New York State Thruway Authority
New York State Canal Corporation

January 3, 2013

Re: NYSDEC Permit No. 3-9903-00043/00011 New NY Bridge Project (formerly known as the Tappan Zee Hudson River Crossing Project) Supplement to the March 26, 2012 Joint Permit Application: Revised Design Drawings

ALL DIMENSIONS IN FT UNLESS OTHERWISE NOTED
 CONTRACT NUMBER: D214134
 SHEET NO. 7 OF 15

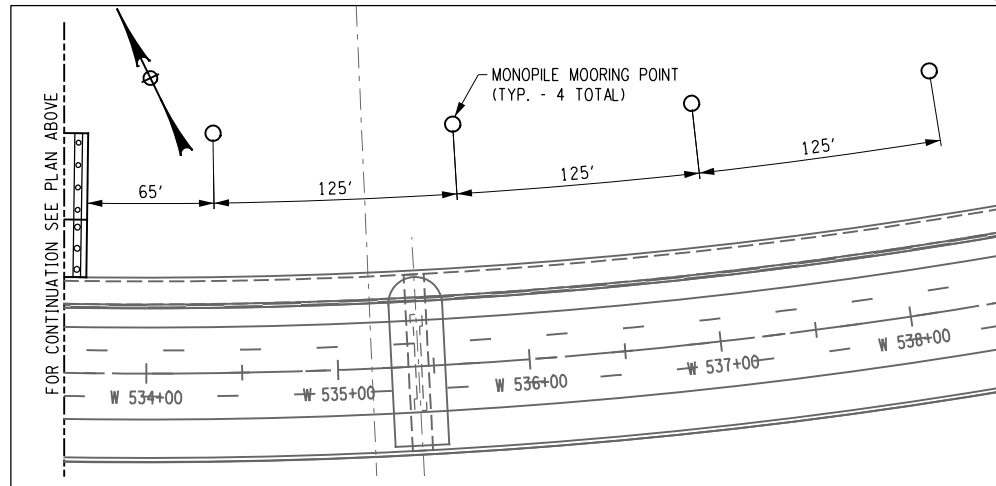
- The bulkhead design, as shown on Sheet 7 of 15, has been revised to eliminate any fill.
- The Permanent North Dock shown on Sheet 7 of 15 has been reduced to 106,435 square feet (2.44 acres) from 150,000 square feet (3.44 acres), as shown on previous drawings.

- NOTES:**
1. NYSTA NORTH DOCK TO BE SUPPORTED ON PILES AND CONNECTED TO BRIDGE PIERS.
